HISTORIC AND DESIGN REVIEW COMMISSION

HDRC CASE NO: 2019-456
COMMON NAME: 1211 E Commerce
ZONING: D
CITY COUNCIL DIST.: 2
APPLICANT: Paul Kahlich/MCS Architects, LLC
OWNER: Raju Bhagat/Kennedy Hotel, LP
TYPE OF WORK: Construction of a 4-story hotel
APPLICATION RECEIVED: August 06, 2019
60-DAY REVIEW: October 05, 2019
CASE MANAGER: Edward Hall

Candlewood Suites - 1211 E. Commerce St, SATX
OHP Review and HDRC Application - MCS Architects Response
July 17, 2019

LANDSCAPE PLAN

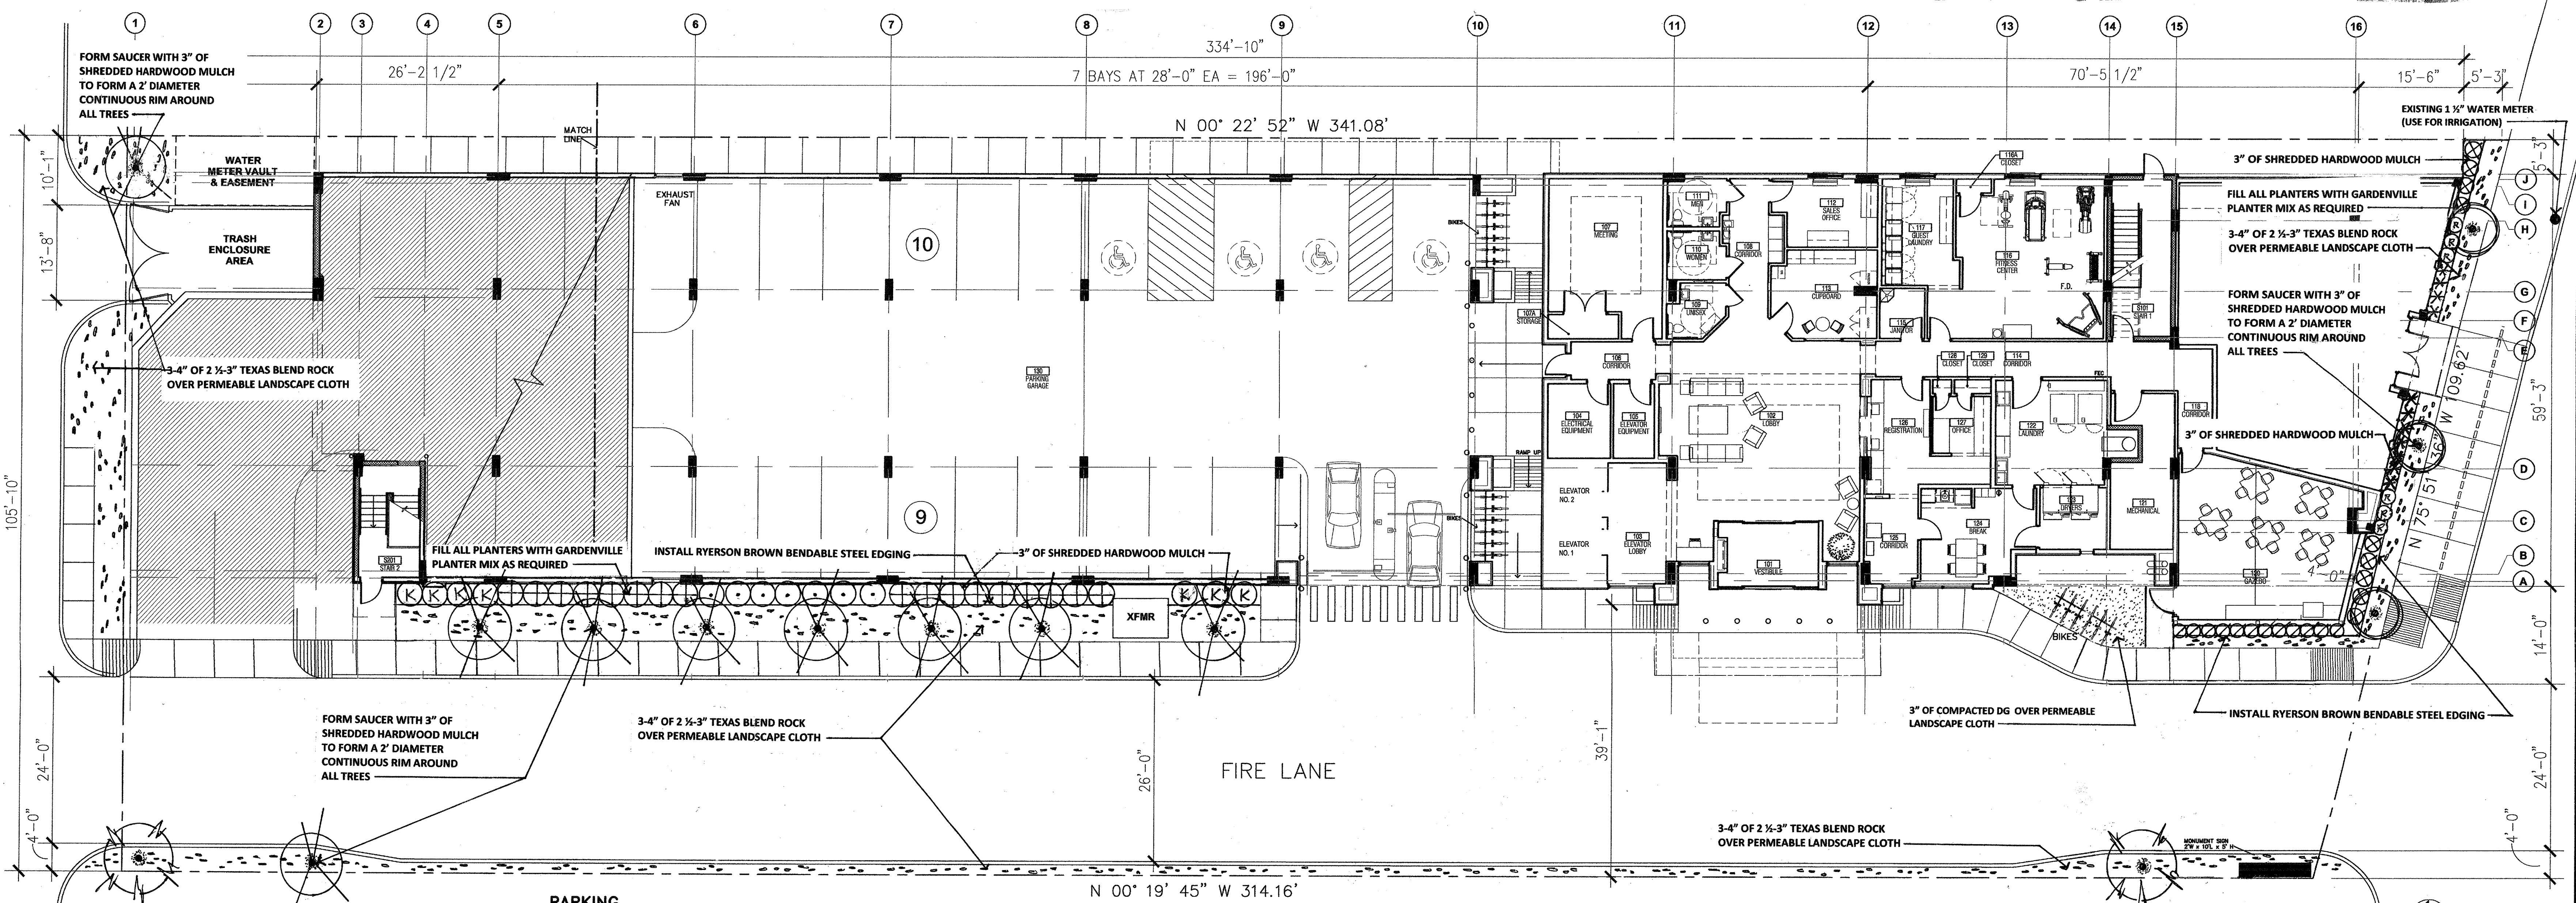
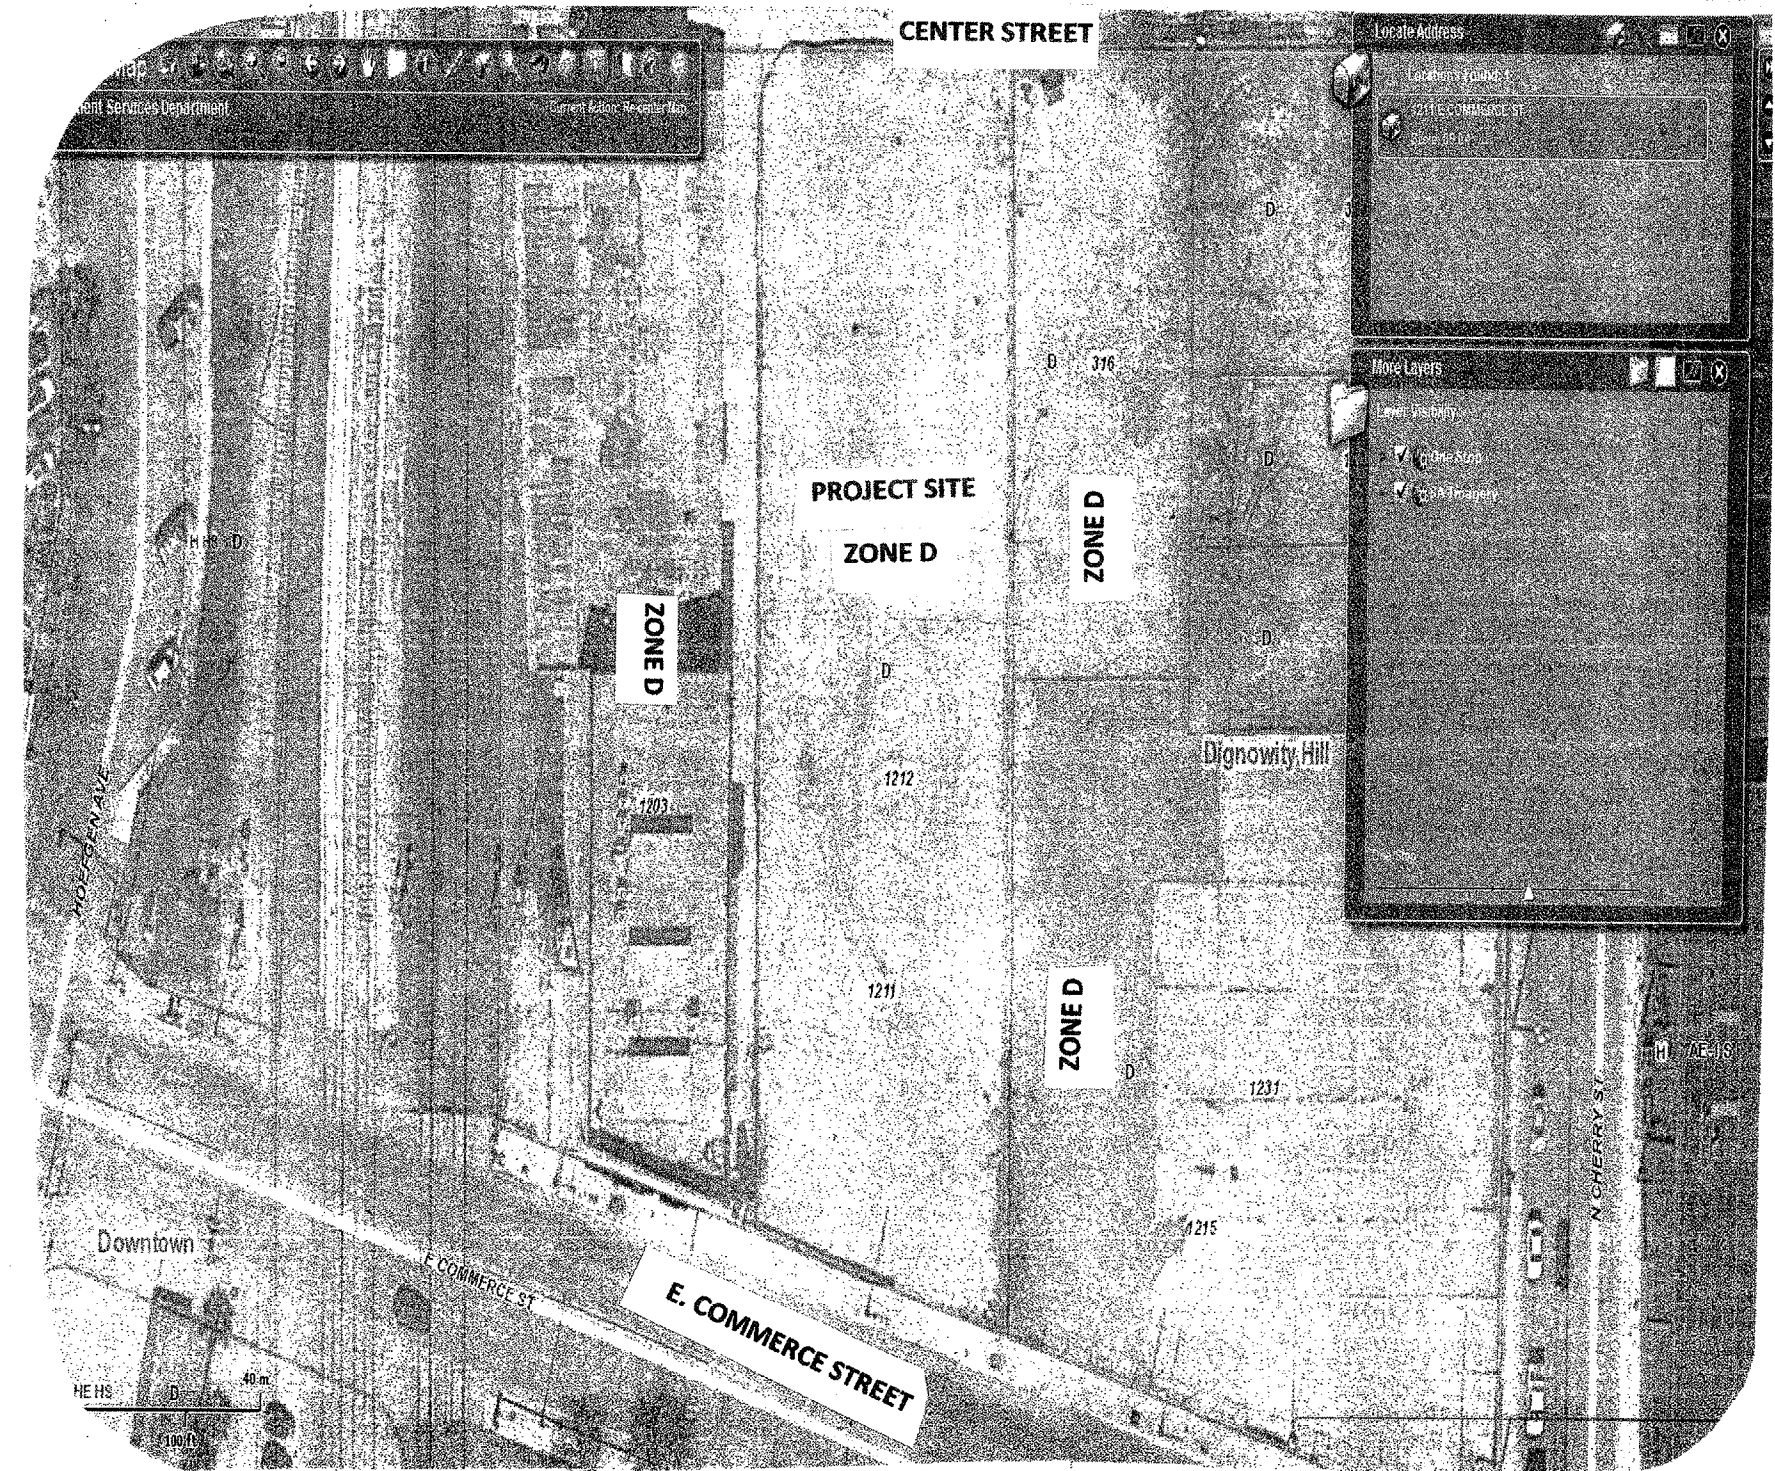
- d. LANDSCAPE & HARDSCAPE – The applicant has noted the installation of a parkway along the curb, as noted in finding b and has noted in the installation of street trees, consistent with the Downtown Design Guide. Additionally, the applicant has provided detailed landscaping plan noting landscaping materials and their planned locations.

ITEM	DESCRIPTION	POINTS
STREET TREES	3 Small for 109 LF along E. Commerce Street (109 LF x .75=81.75 LF divided by 30=2.72 rounded up to 3 trees required and planned)	25 POINTS
TOTAL Required		25 POINTS

TREE CANOPY	34,762 sq. ft. total site square footage X .25 = 8,690.5 sf canopy required
	Actual Shading Provided:
	2 Large Trees @ 1200 x .90= 2,160.00 sq. ft.
	9 Large Trees @ 875 x .90= 7,087.50 sq. ft.
	3 Small Trees @ 275 x .90 = 742.50 sq. ft.
	Actual Total Shade Provided: 9,990.00 sq. ft.
TOTAL CANOPY PROVIDED:	9,990.00 sq. ft.
PERCENTAGE CANOPY PROVIDED:	28.74%
